To: INCITS Technical Committee T10  
 From: Kevin Butt  
 Date: May 9, 2007 8:44 am  
 Document: T10/06-462r8 — SSC-3: Keyless Copy

### 4.2.20.4 Keyless copy of encrypted data

FIGURE 1. Example of a keyless copy operation

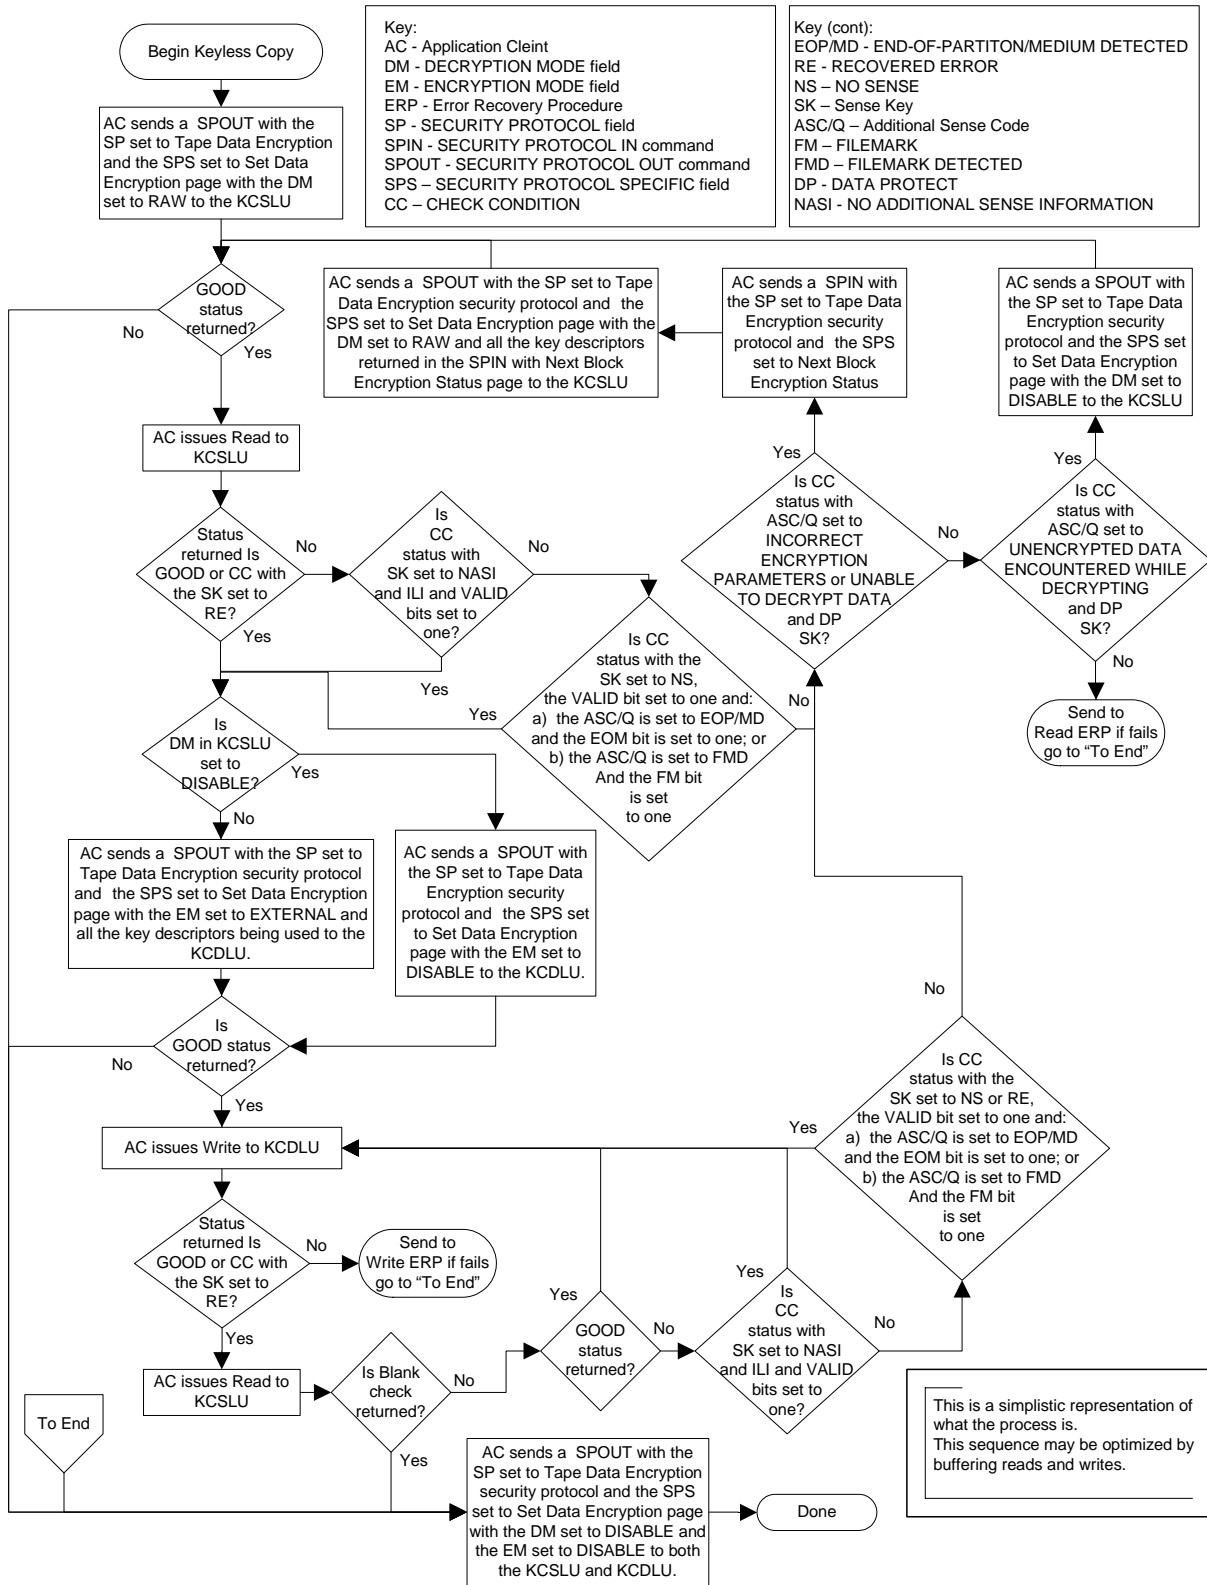
8. 06-462r5 Modified the figure to describe an example of how an application client might implement a keyless copy, listed where to return to the flowchart for ILI and FM Check Conditions.

10. 06-462r7 Correct list for detecting errors in the Set Data encryption pages that contain M-KAD. Modify flowchart to show transitions between unencrypted data and encrypted data during a keyless copy.

To accomplish a keyless copy operation an application client sets the KCSLU decryption mode to RAW and the KCDLU encryption mode to EXTERNAL. The application client then reads one or more logical objects from the KCSLU and writes those logical objects to the KCDLU. During this process if the KCSLU detects a mismatch between the key-associated data in the data encryption parameters and the key-associated data on the medium during a read operation, the KCSLU returns a CHECK CONDITION status to the application client to notify it that some action is required. An example of this is shown in the informative flowchart in Figure 1 on page 5.
